# ***Appendix C – Plan for Interim Operation***

<sup>1</sup> Addendum No. 1 dated May 8, 2023

**FIGURE 5**

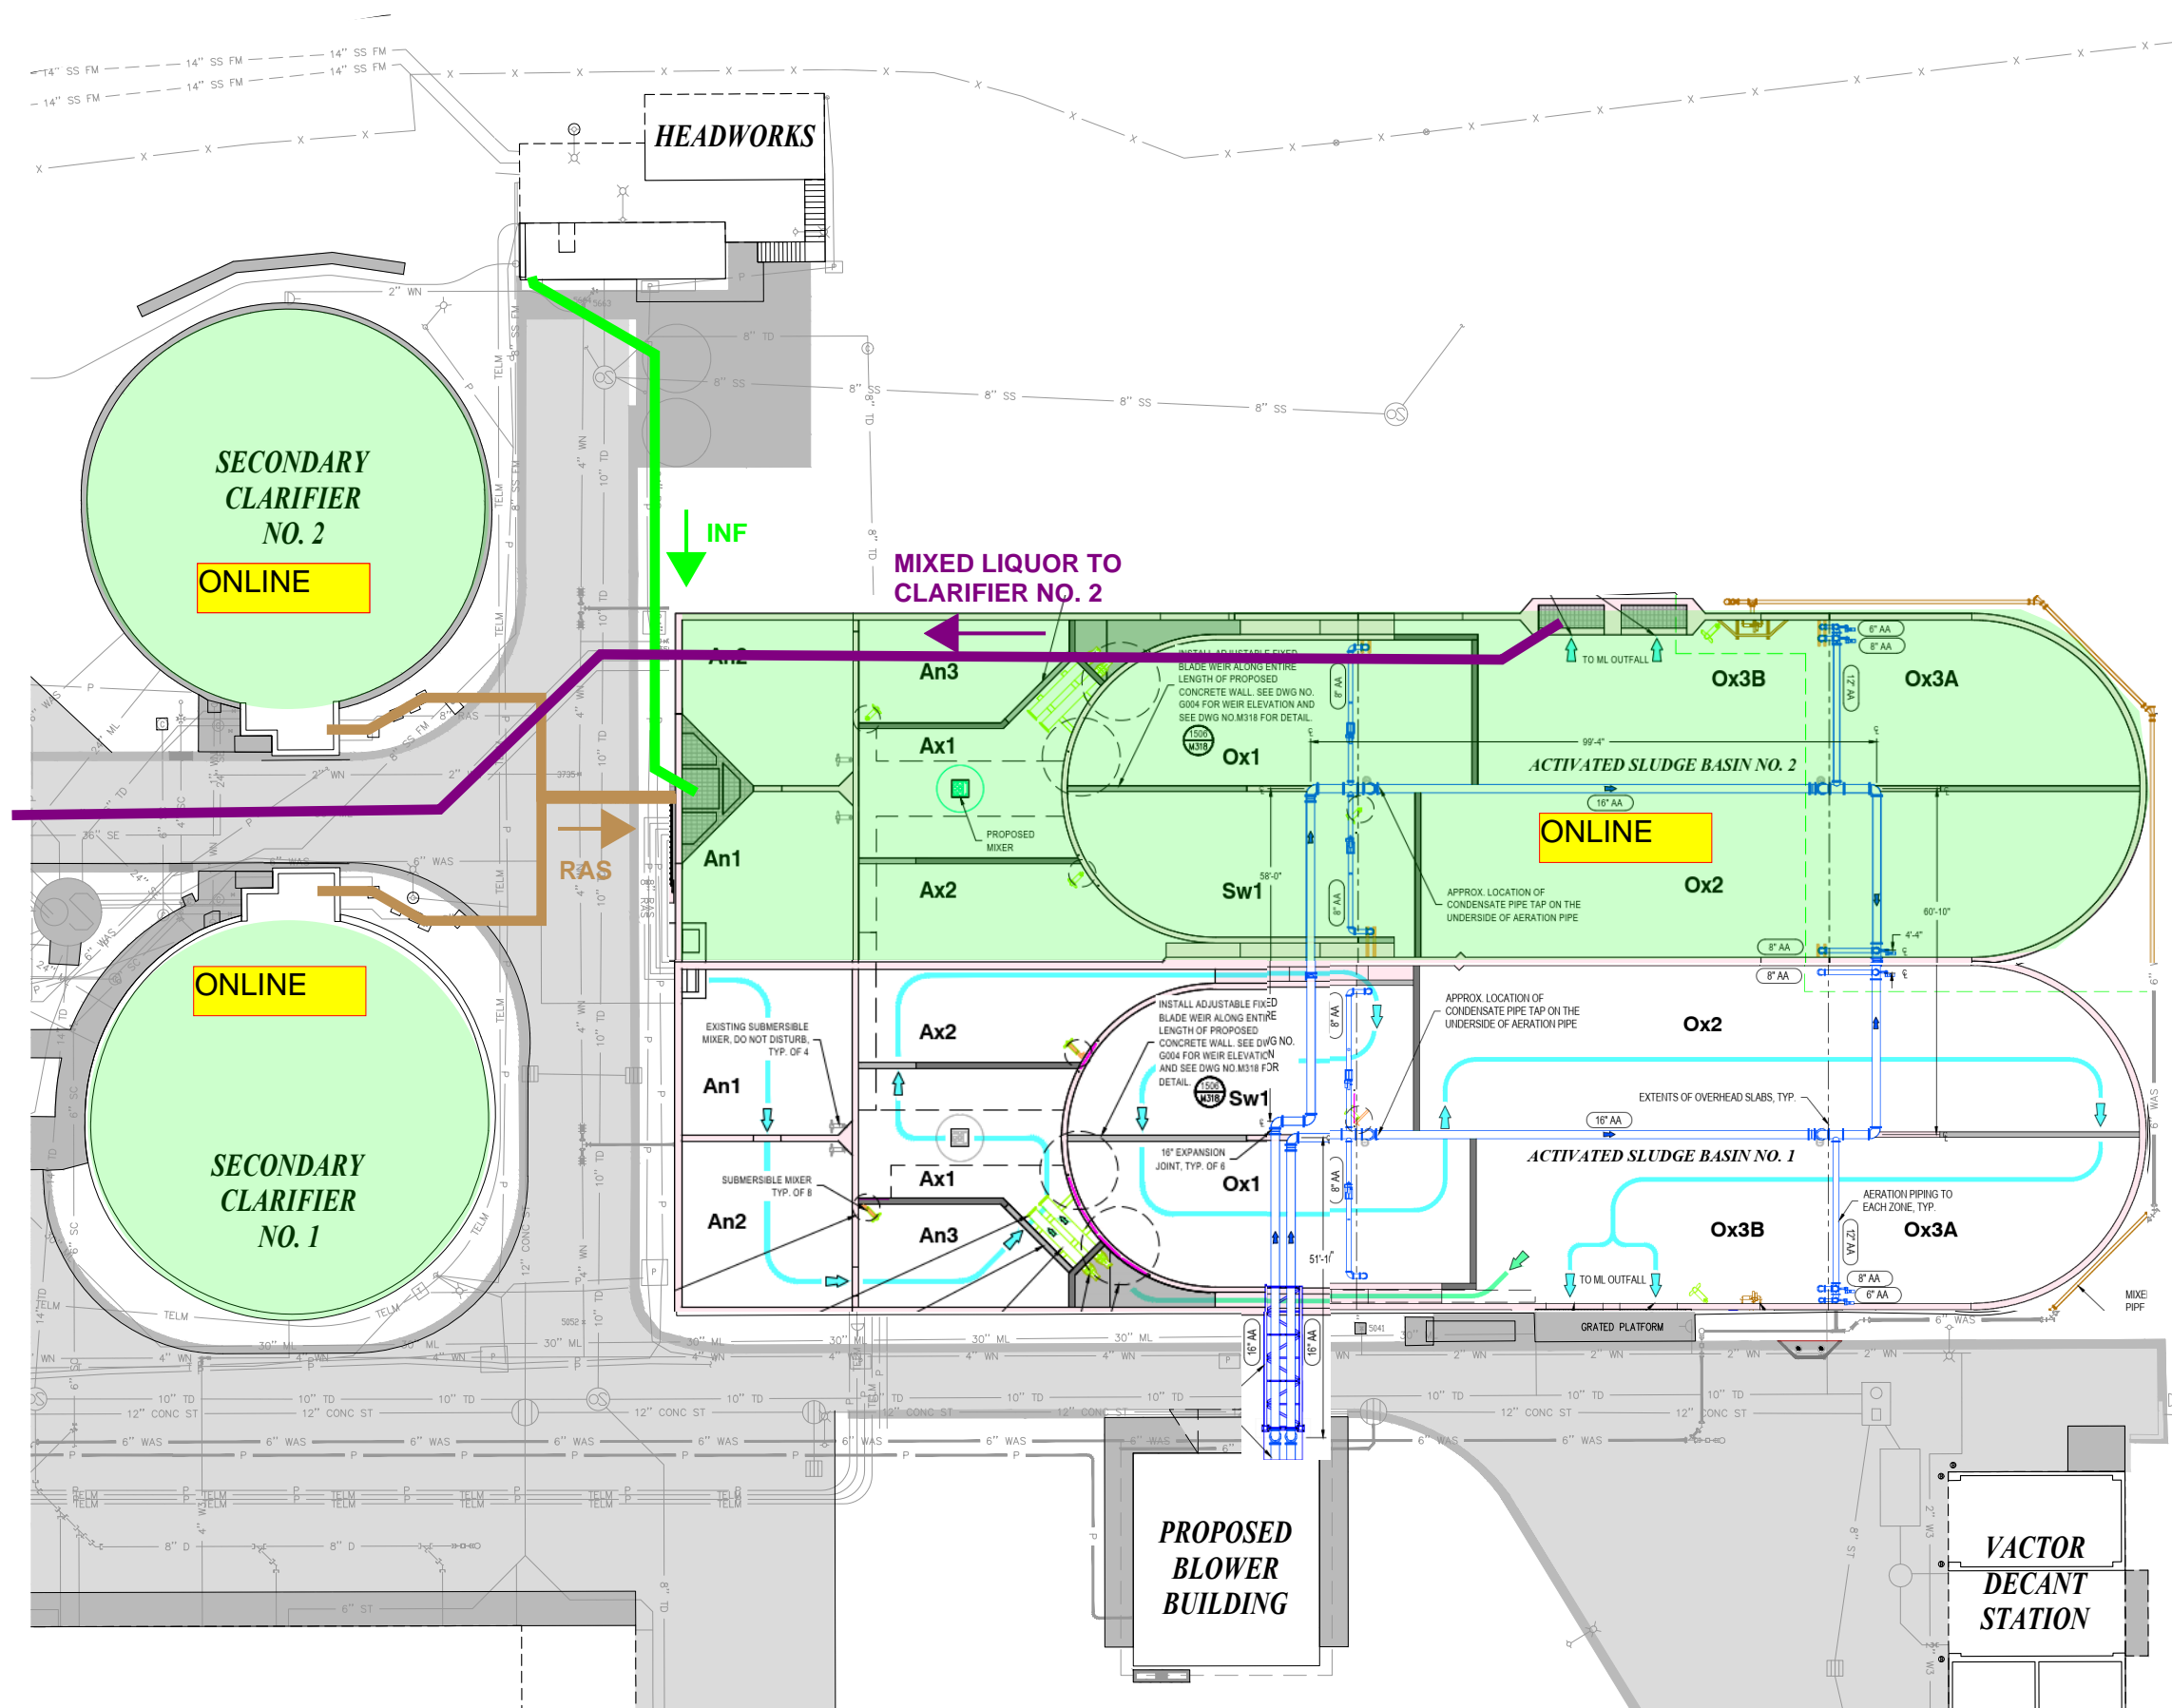
4. The sludge remaining in Ditch No. 1 will settle once mixing and aeration are suspended. ~~It is expected that less than 100,000 gallons of sludge will remain in the ditch after the supernatant is pumped out. The Contractor will remove and dispose of this remaining sludge.~~ **The Contractor is required to hose and pump settled activated sludge to the clarifier until the anticipated amount of material is remaining as described in Division 1.72 of the Technical Specifications. The Contractor must remove and dispose the remaining grit, sludge, and other materials unable to be pumped to the clarifier. The Contractor shall submit documentation describing their removal approach and disposal location and will coordinate with the City on any procedures to ensure Washington State Department of Ecology's process requirements are met.** The Contractor and WRF staff will coordinate to ensure sludge is not drained to the in-plant pump station.<sup>1</sup>
